**SANITARY SEWER SIPHON  
and  
48" WATERLINE RELOCATION**

**19th AVENUE and HATCHER ROAD**

**CONTRACT NO. FCD 87-26**

CROSS SECTION THRU FIRE HYDRANT BLOW OFF

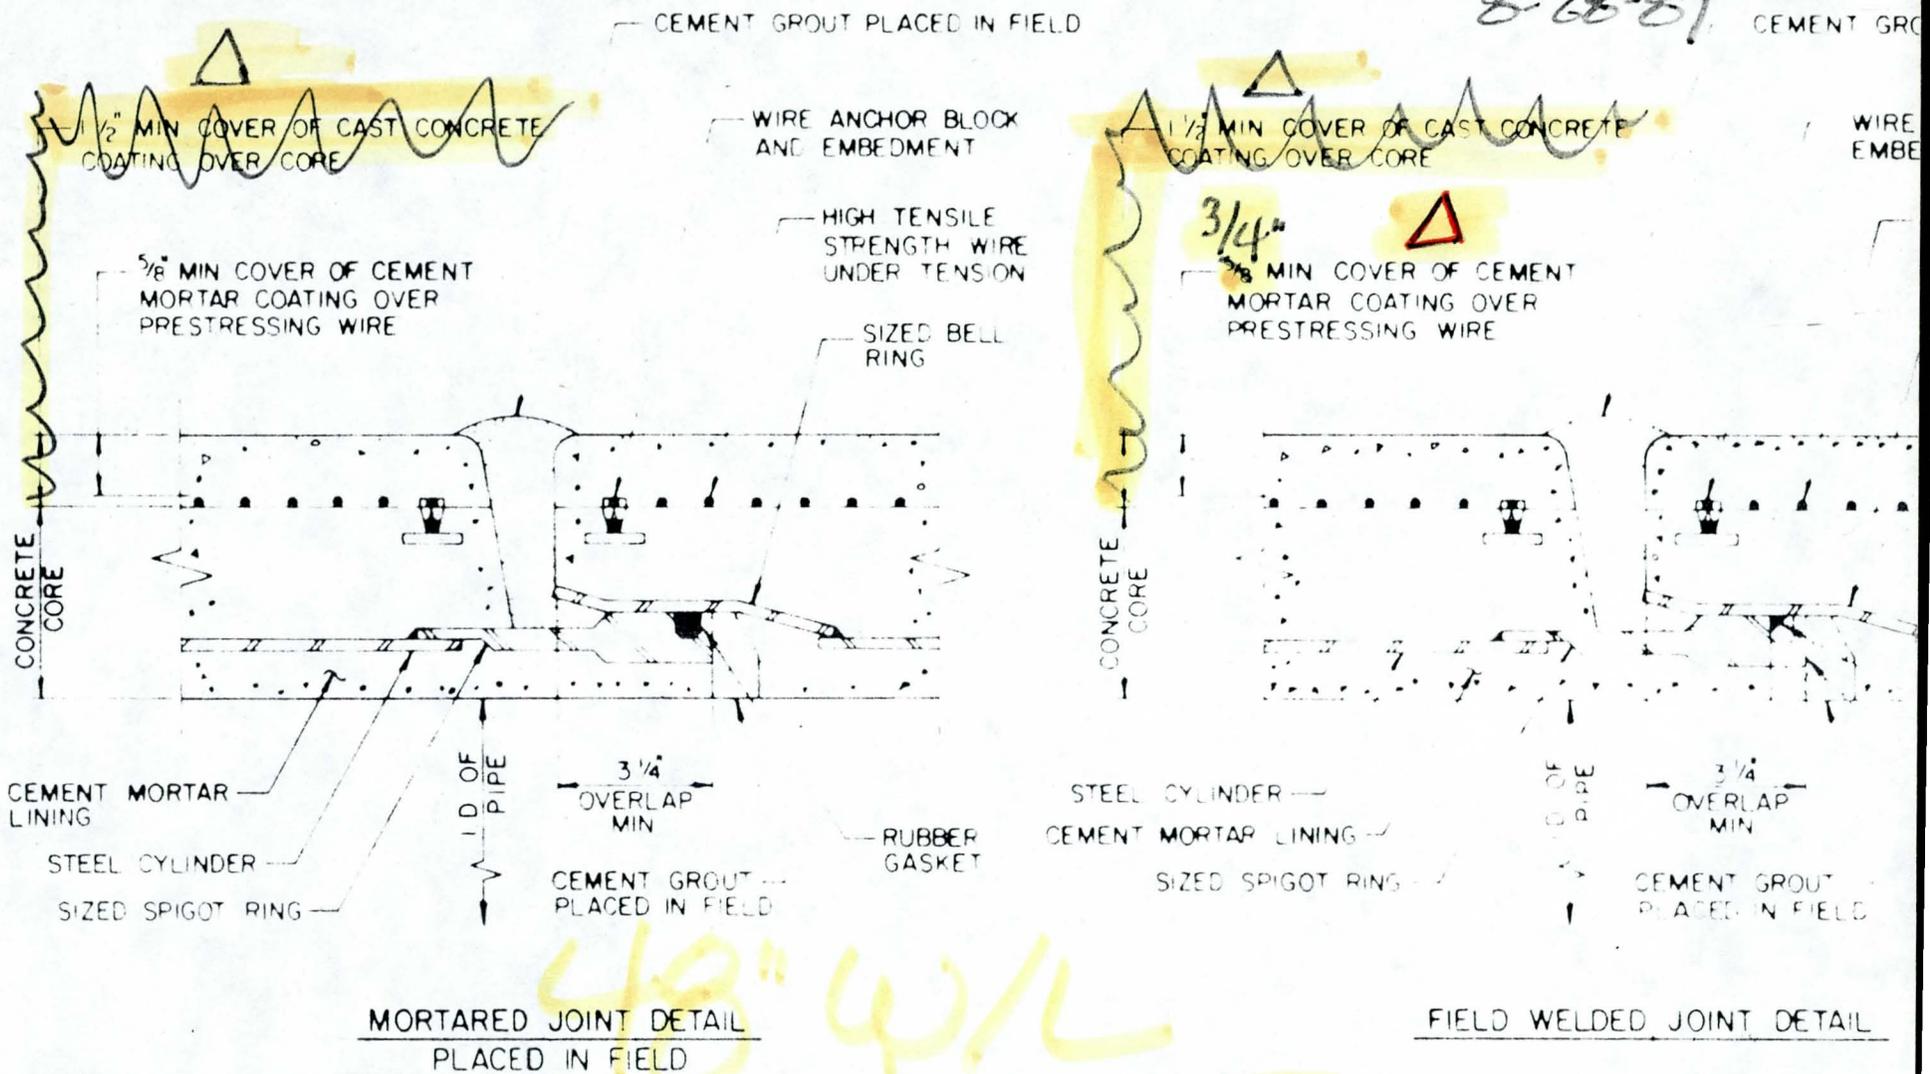
9. Construction plans Sheet 4 of 7, revise detail L-5 as shown on the attached exhibit "C".

EXHIBIT A

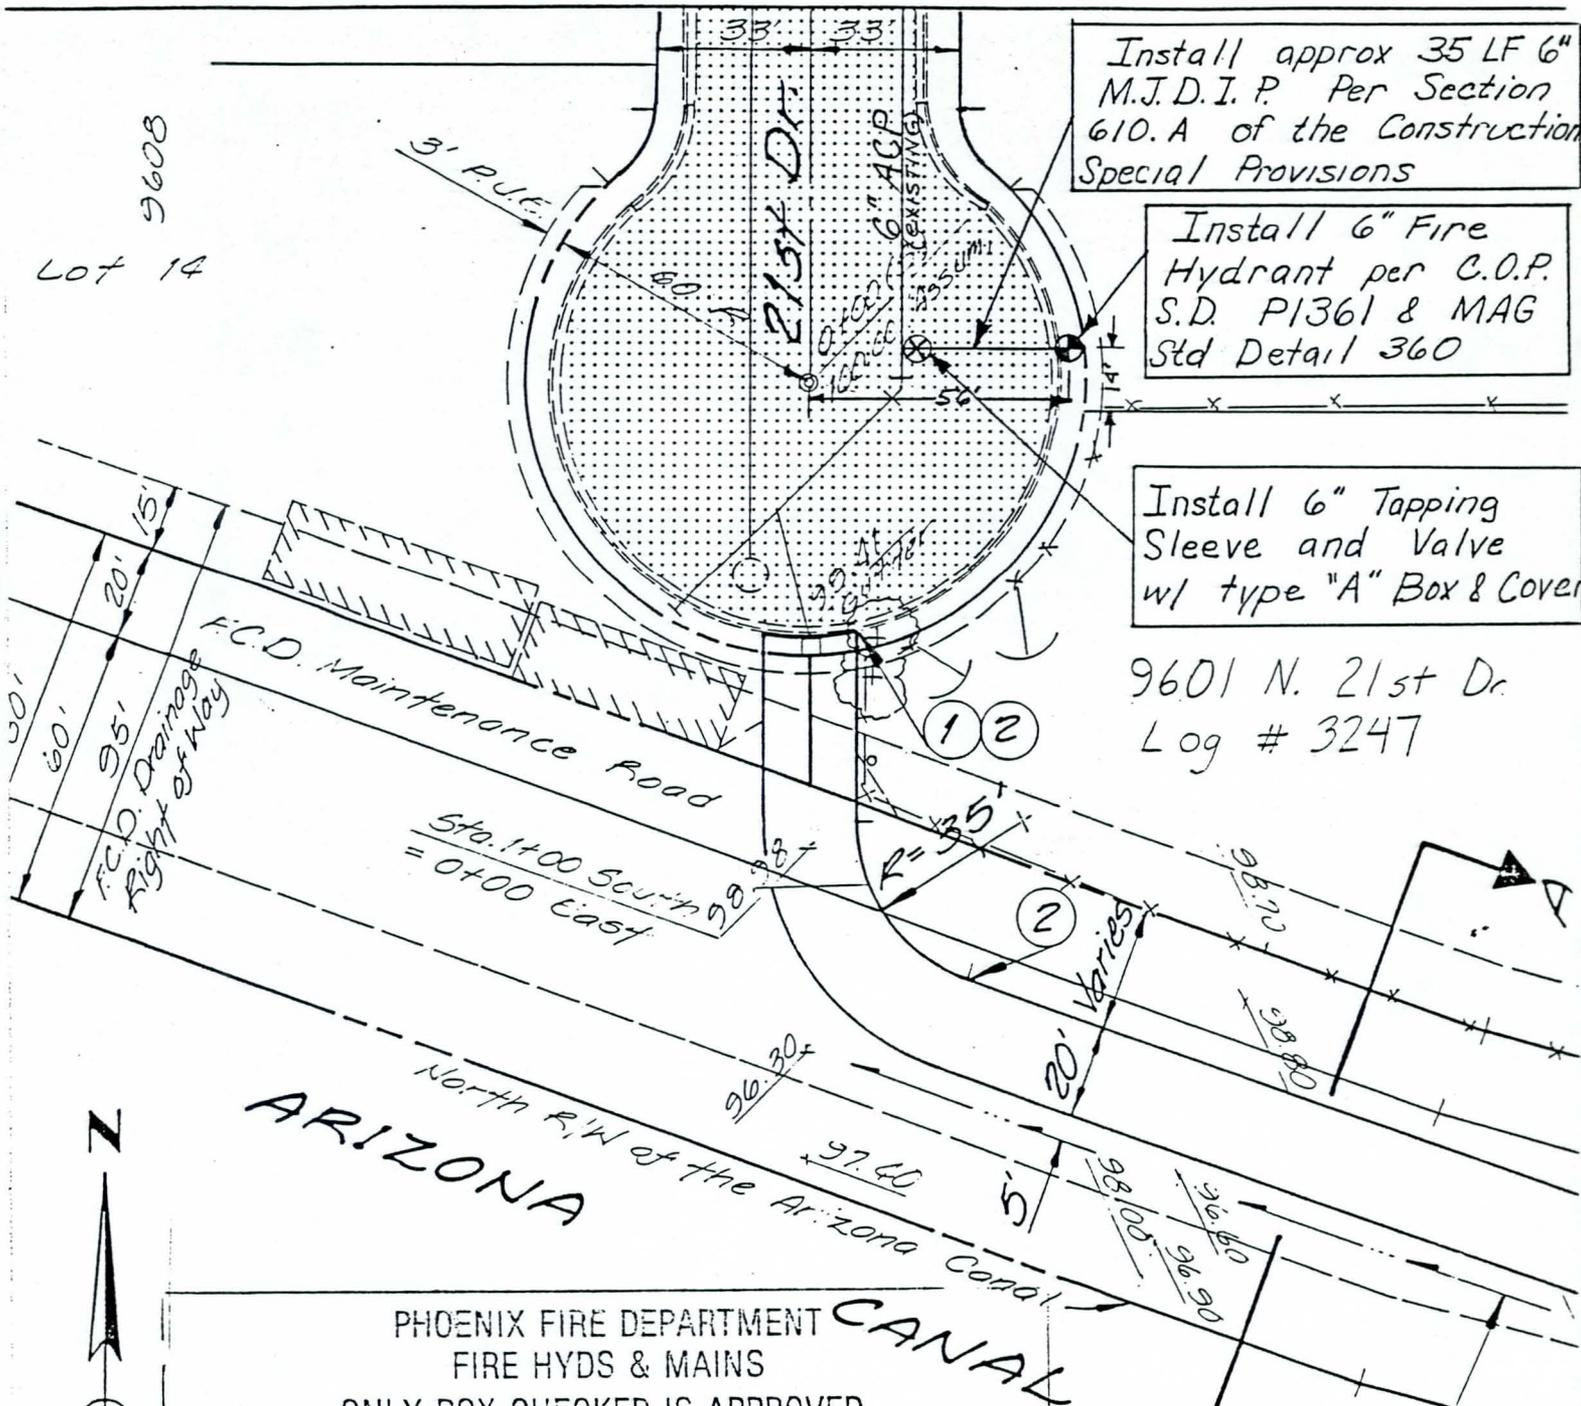
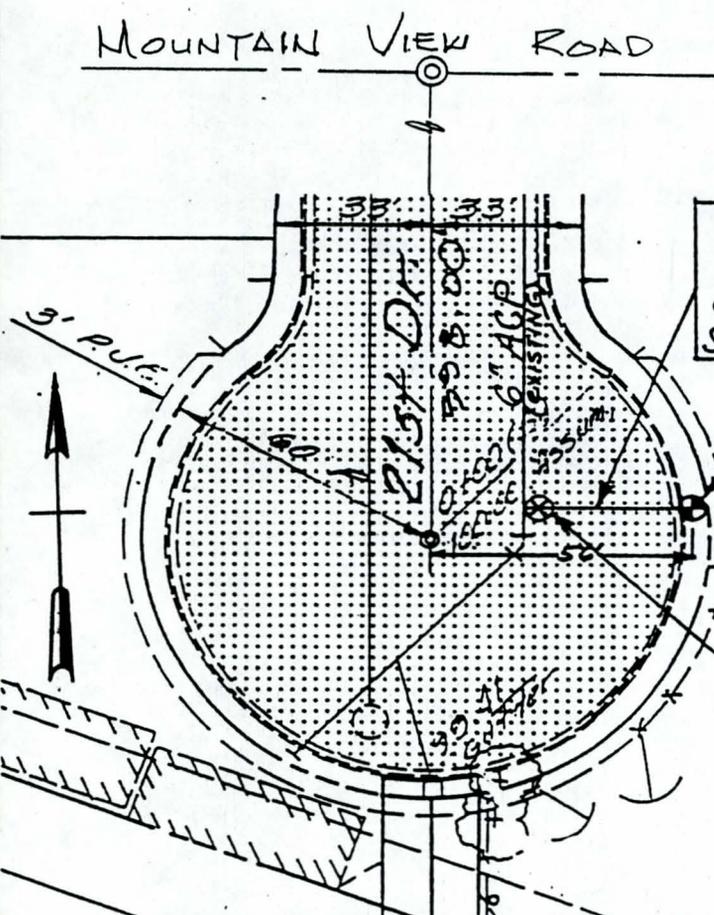
10. Construction plans Sheet 7 of 7, modify Sheet 7 to include the installation of the fire hydrant, 35 L.F. of 6" M.J.D.I.P., tapping sleeve, valve box and cover at 21st Drive, as shown on the attached exhibit "A".

Install approx 35 LF 6" M.J.D.I.P. Per Section 610.A of the Construction Special Provisions

Install 6" Fire Hydrant per C.O.P. S.D. P1361 & MAG Std Detail 360

EXHIBIT B

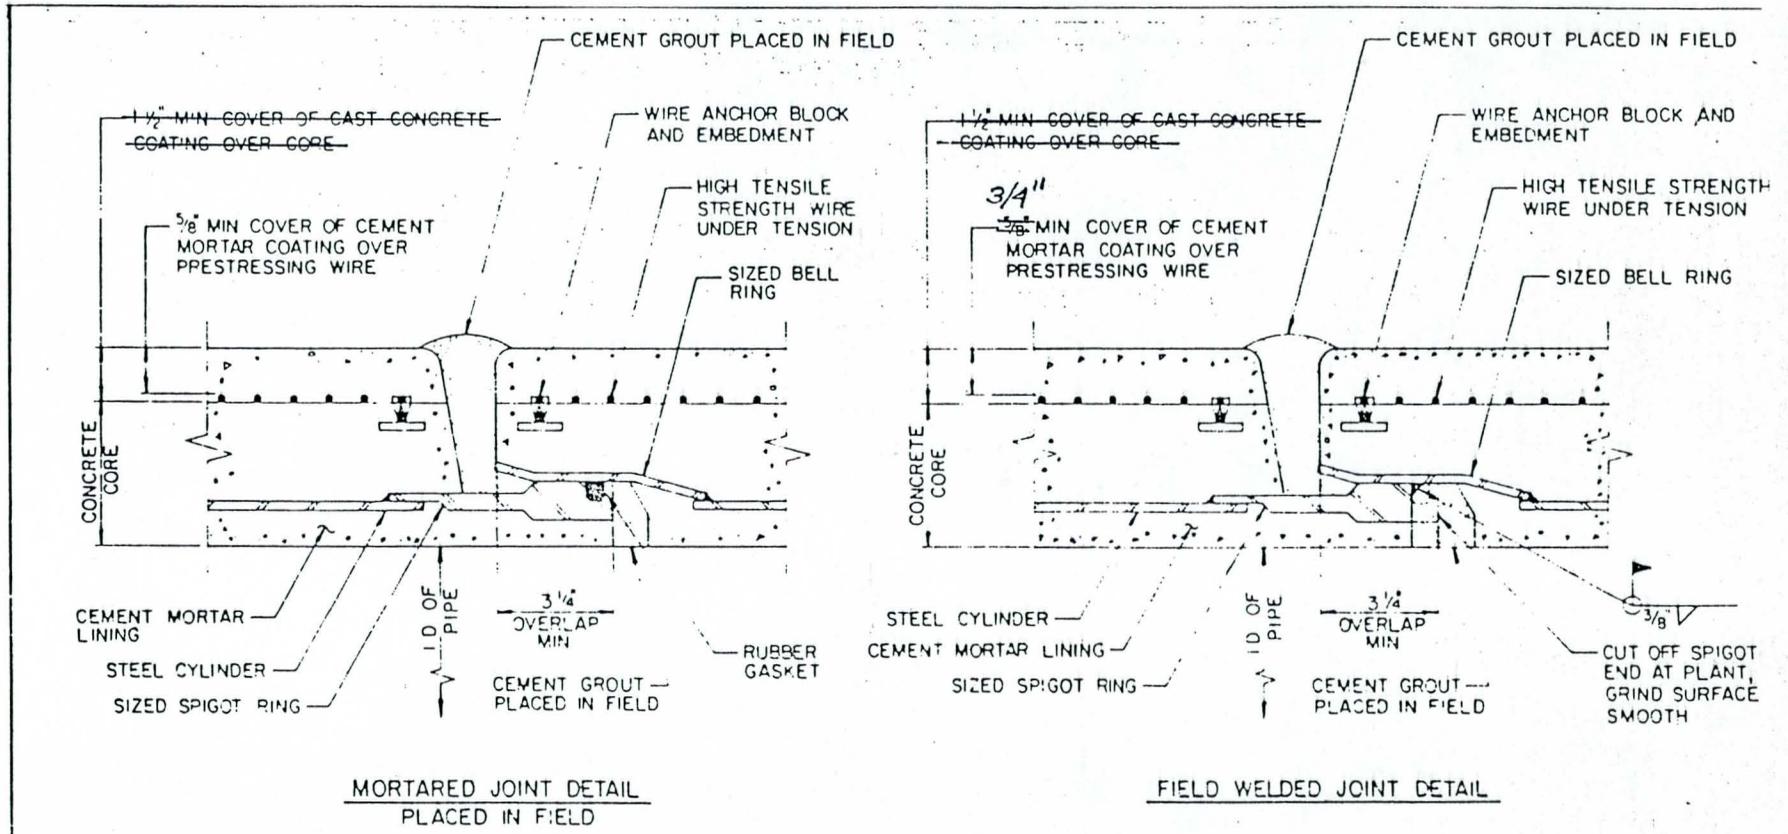
12. Construction Plans Sheet 9 of 10, Staff Gauge Detail, revise the Staff Gauge Marking Schedule as shown on the attached exhibit "B".

STAFF GAUGE MARKING SCHEDULE
